STAFF REPORT 10-13-2021 REGULAR MEETING

APPLICATION NUMBER: 21-7524

ADDRESS: 8029 COE, 1500-1532 VAN DYKE

SCOPE: ERECTION OF 4-STORY MULTI-FAMILY/TOWN-HOME BUILDING DEVELOPMENT REQUIRING DEMOLITION OF TWO HOUSES

EXTERIOR RENDERINGS

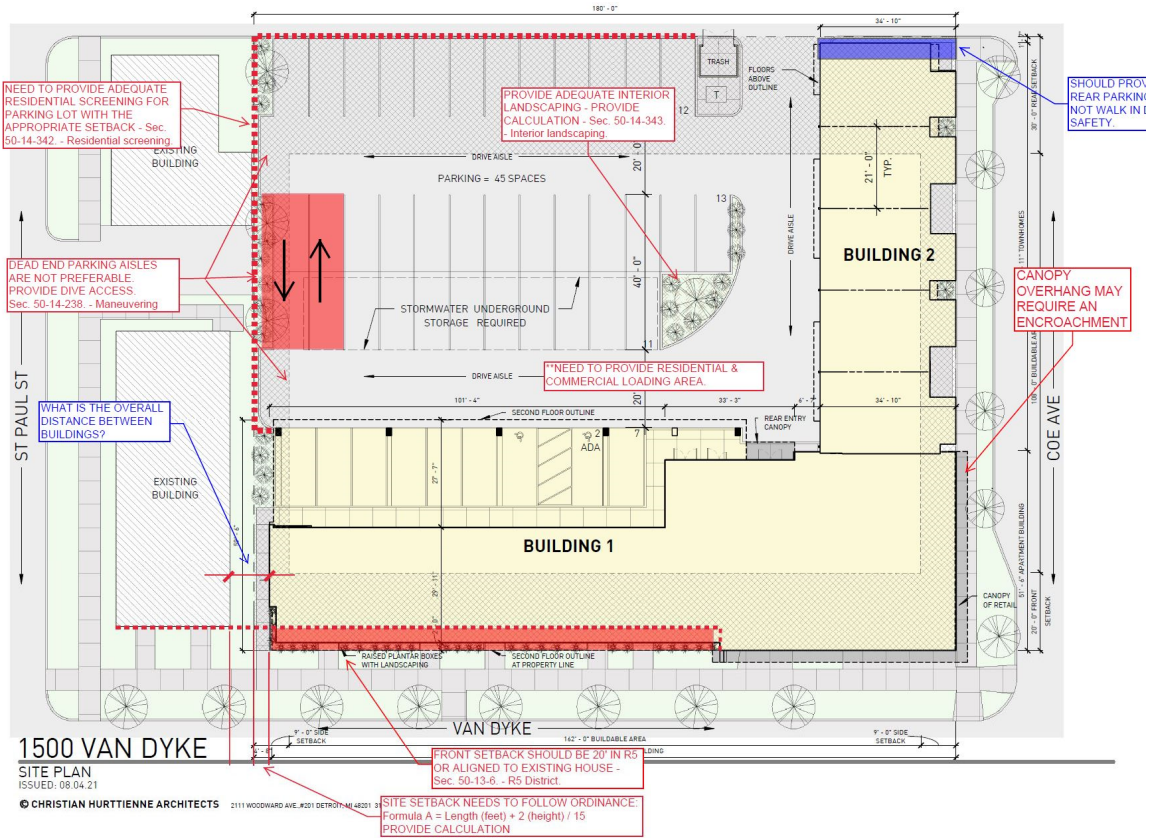
THIS IS INTENSE. THE BUILDINGS FRONT SETBACK AS WELL AS THE HEIGHT AT THIS END SHOULD LINE UP WITH THE EXISTING HOME.

1 VAN DYKE ELEVATION

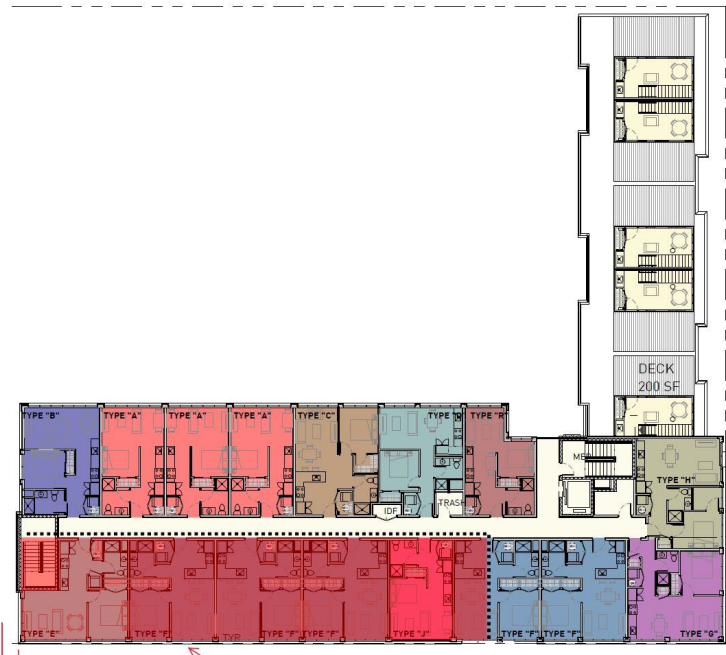
THE ELEVATION ALONG VAN DYKE NEEDS TO STEP DOWN TO MATCH THE HEIGHT OF THE ADJACENT EXISTING HOUSE.

SITE SETBACK NEEDS TO FOLLOW ORDINANCE: Formula A = Length (feet) + 2 (height) / 15. PROVIDE CALCULATION.
